## TECHNICAL EVALUATION REPORT

EVALUATION OF SPENT FUEL RACKS STRUCTURAL ANALYSIS

OYSTER CREEK NUCLEAR GENERATING STATION

GPU NUCLEAR

Figure 1. Dynamic Model

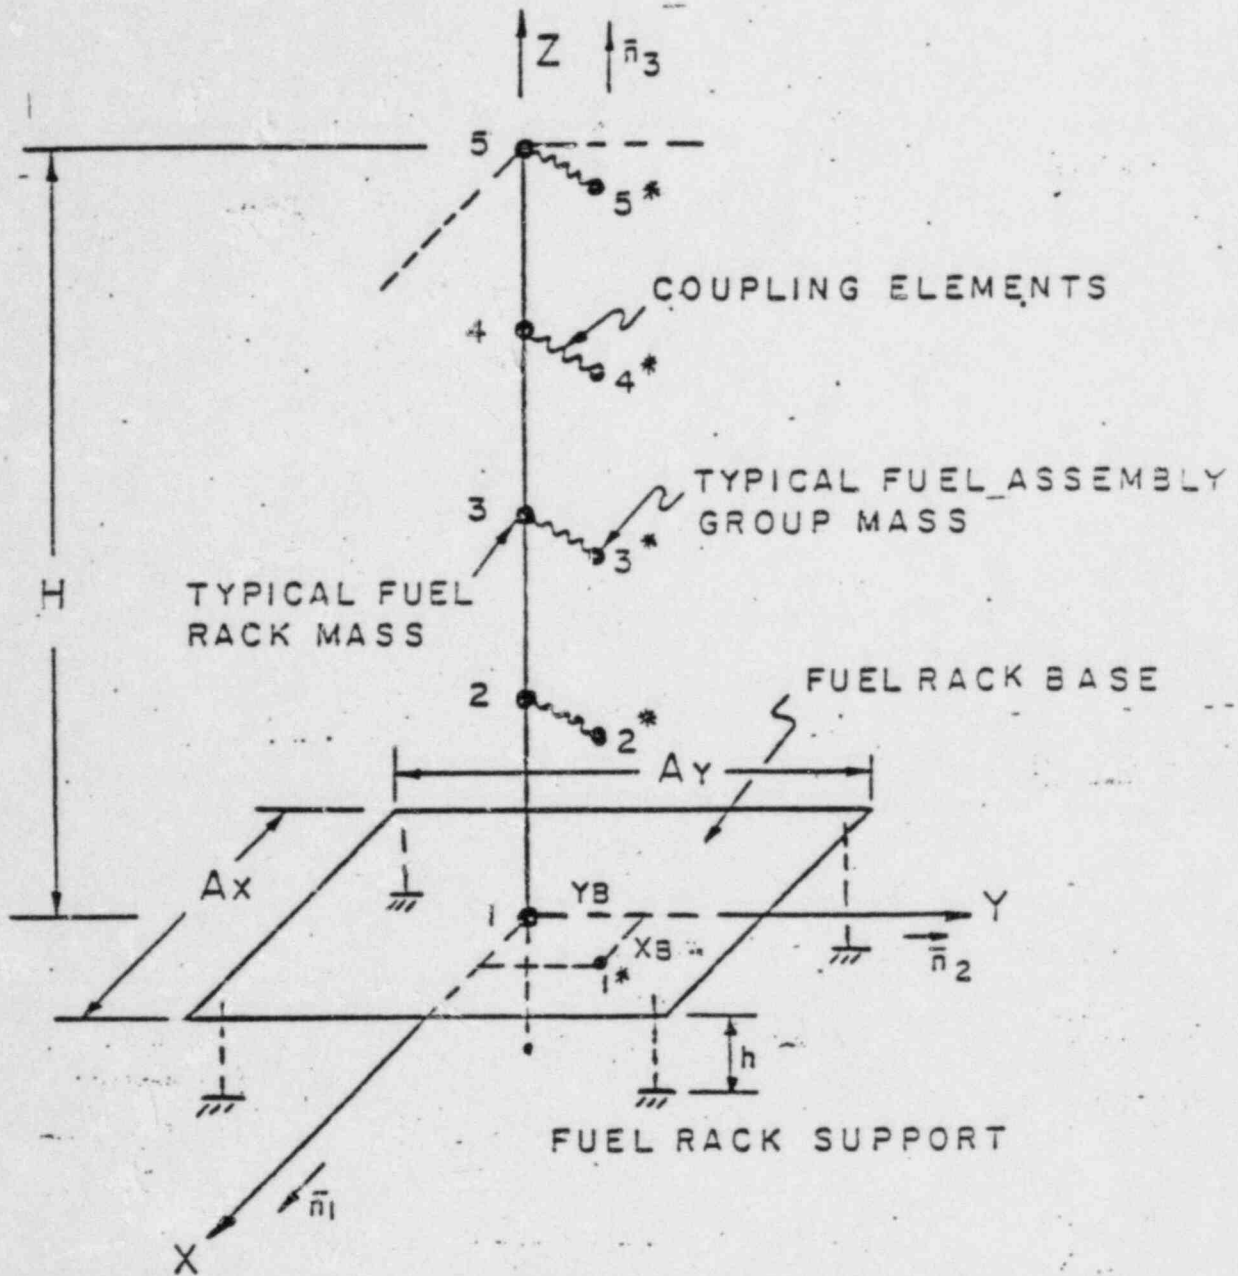
Assumption "a" was made to reduce the collection of fuel racks in the spent fuel pool to a manageable three-dimensional problem--that of one rack

module. The assumption offers a degree of conservatism in that it reduces the available clearance space between rack modules for dynamic displacement without impact to one-half the initial clearance. A further discussion of its effects upon hydrodynamic coupling is presented in Section 3.3.3 of this report.

Assumption "b", said to offer conservatism, is not necessarily conservative. Regardless of the initial position of each individual fuel assembly, all fuel assemblies within a fuel rack module will settle into in-phase motion soon after the rack module is set in motion. This is because each fuel assembly is a long vertical column which pivots about its base and moves within a very small clearance within the rack cell.

Since the Licensee has not taken any credit for impact structural damping of the limber fuel assembly, it appears that a small amount of damping could be justified as either impact damping or equivalent fluid drag without compromising the conservatism of the analysis.
